# Southgate KXLY

## Recommendation Meeting

### Staff Report

March 13, 2017

PEDESTRIAN CONNECTION TO PARK,  
BETWEEN BUILDINGS AND WITHIN PROJECT

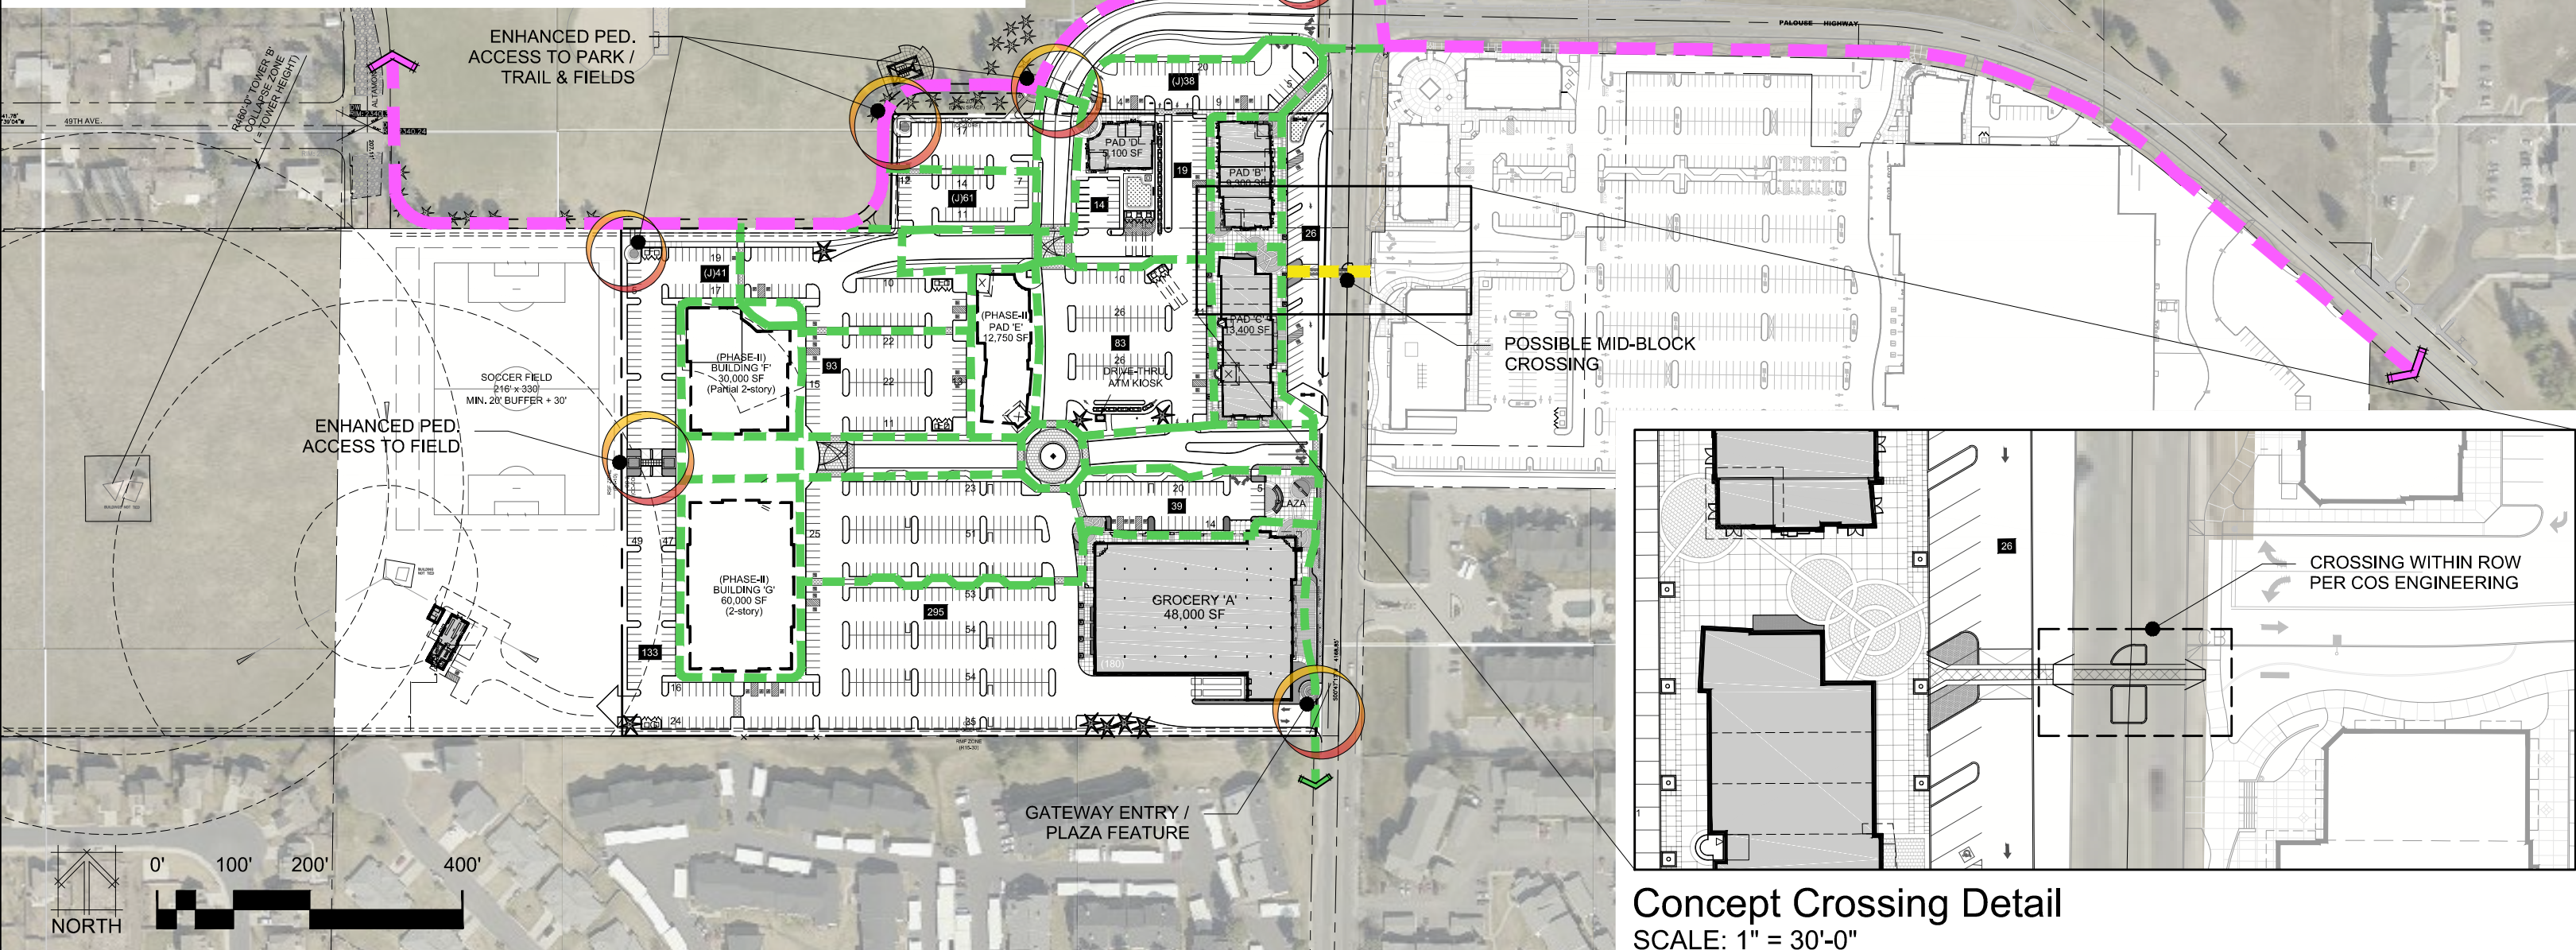
**DRB Guidance:**  
Applicant to provide additional detail on what is proposed for the pedestrian paths between the playfields and the development site.

City proposed mid-block crossing – Option 3

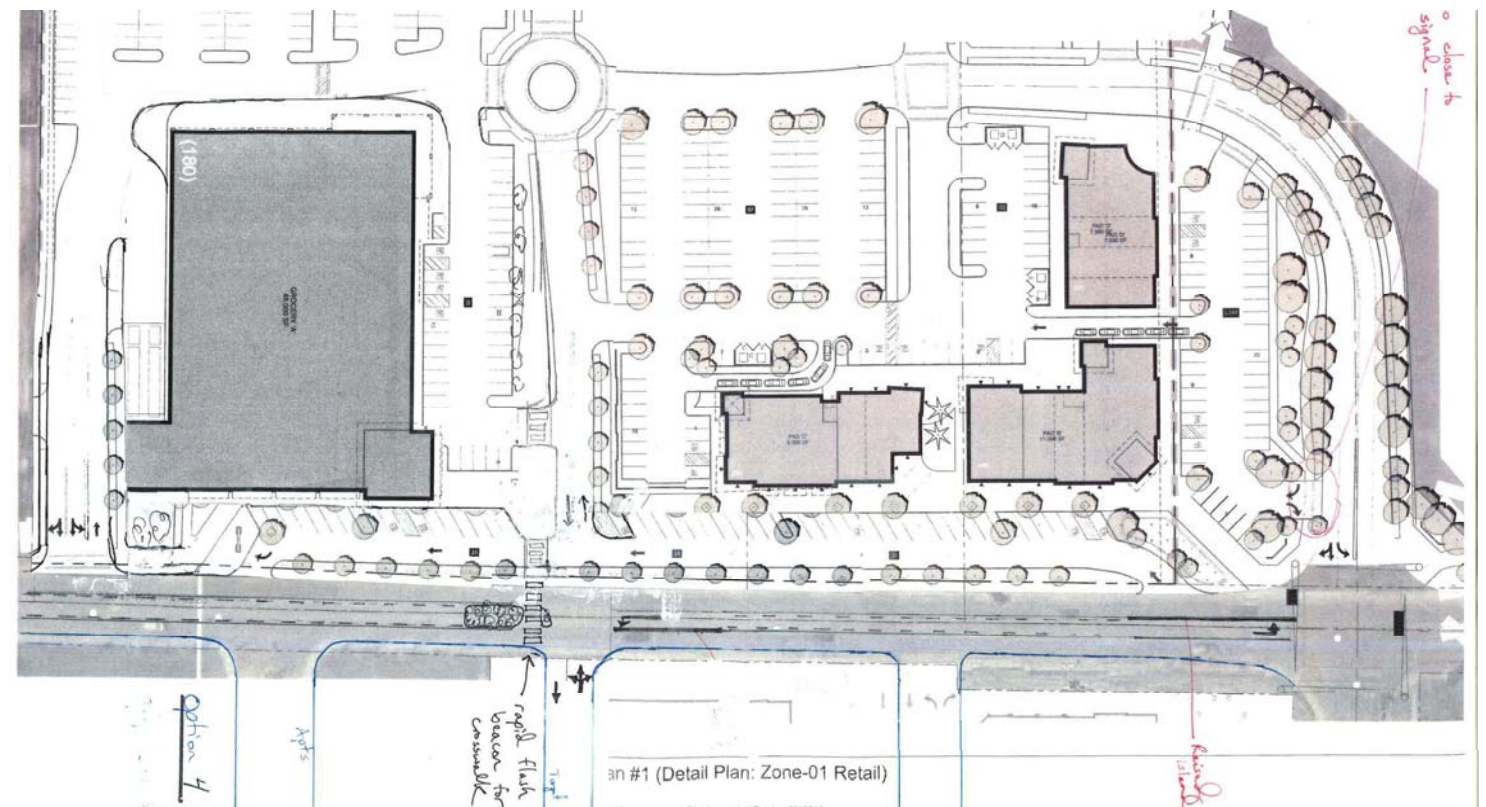
DRB Guidance: *“Applicant to pursue a mid-block, enhanced pedestrian crossing that strives to align with the proposed grid across Regal south of the Palouse Highway intersection in order for the proposal to evolve into an urban district per Section 5.6 of the Development Agreement.”*

A conceptual detail showing the potential Regal St. mid-block pedestrian crossing is shown on Page 036 .

## Neighborhood: STA HPA

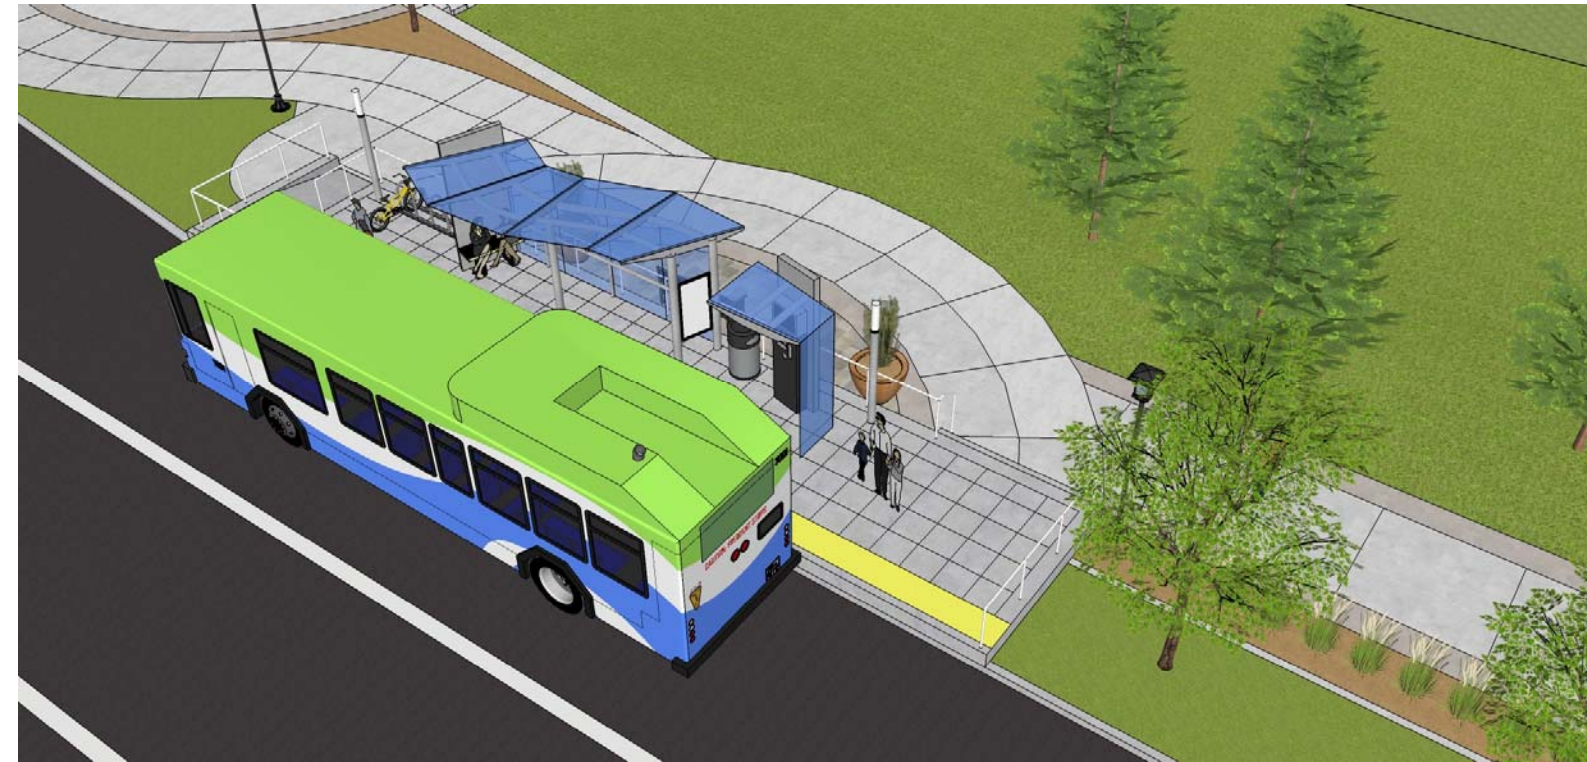
DRB Guidance: *“Work with STA to determine how to best incorporate the future High Performance Transit stop into the development.”*

The development team met with representatives from the Spokane Transit Authority to discuss integrating a future HPT stop into the project. Several locations were discussed. In the end it was decided that a location nearest the northwest corner of the Regal and Palouse intersection would centrally service both the shopping center and sports complex in addition to offering the most direct, convenient and safest access to the crossing of the controlled intersection.

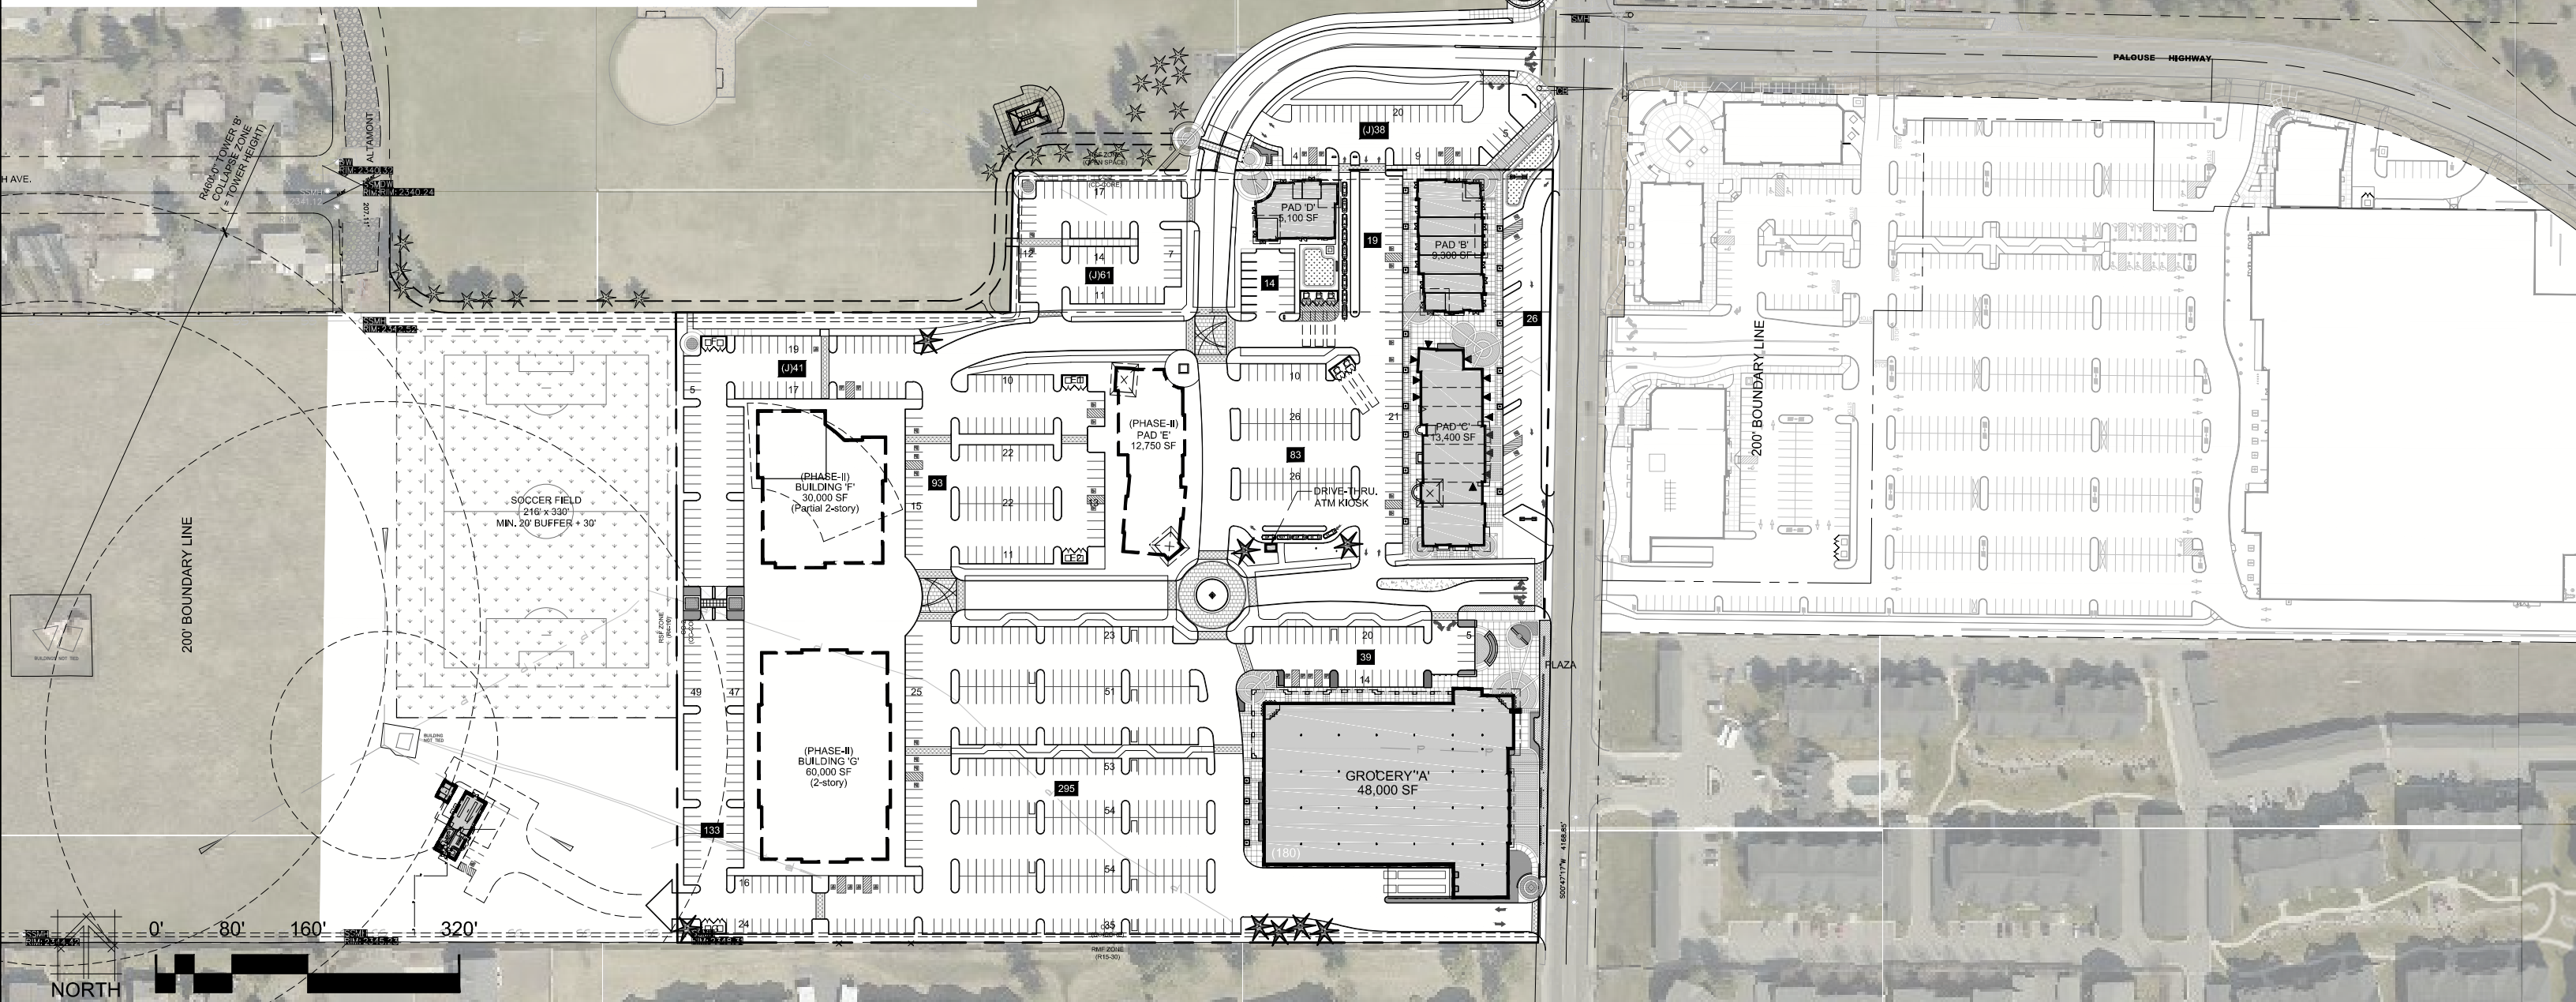
*"The applicant shall look into opportunities to provide either additional site trees and/or provide select trees of greater size in lieu of saving the two existing ponderosa pines which are in poor health and may be difficult to save."*

**Applicant Response:**

1 SCHEMATIC LANDSCAPE PLAN  
SCALE: 1" = 80'-0"

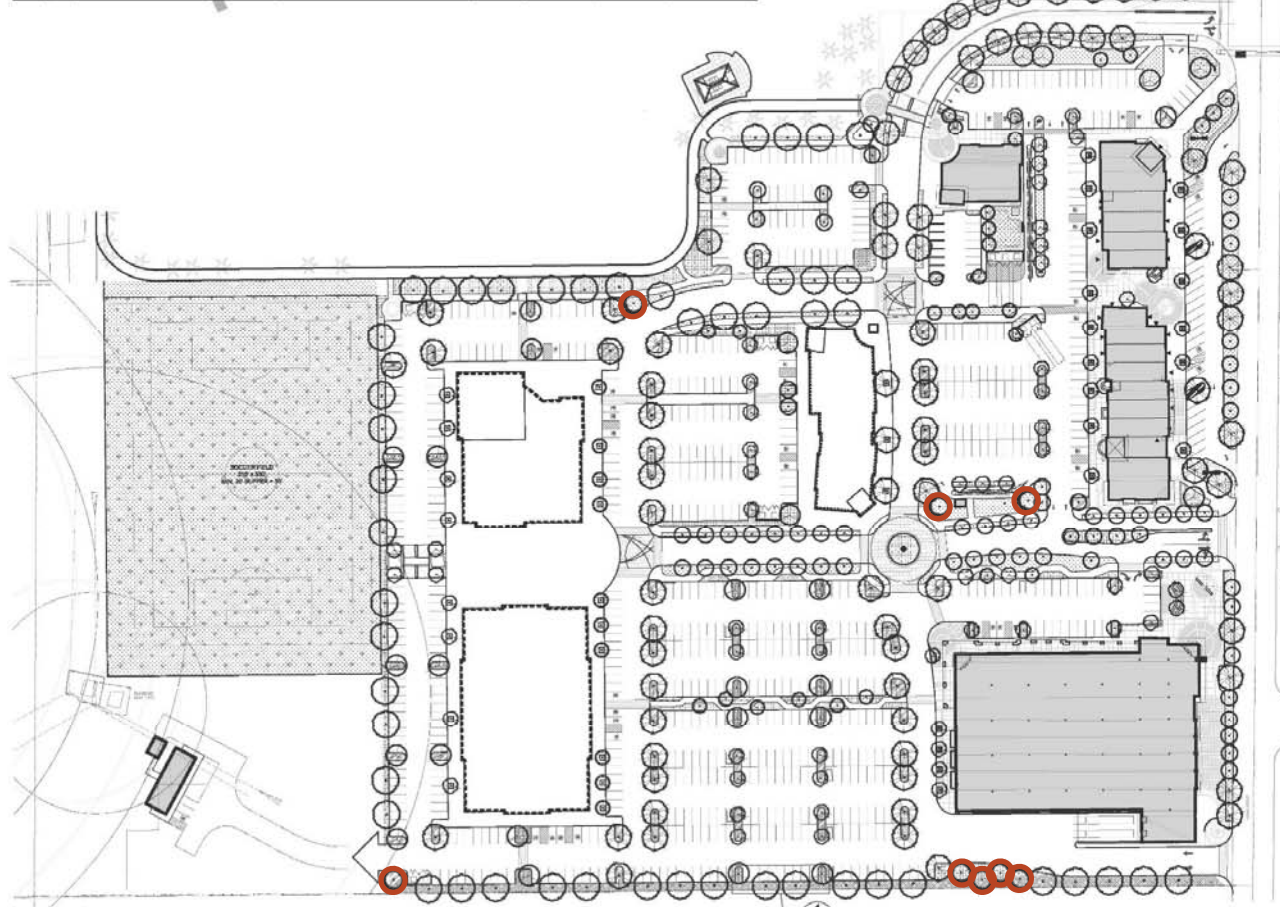
DRB Guidance: "The applicant shall look into opportunities to provide either additional site trees and/or provide select trees of greater size in lieu of saving the two existing ponderosa pines which are in poor health and may be difficult to save."
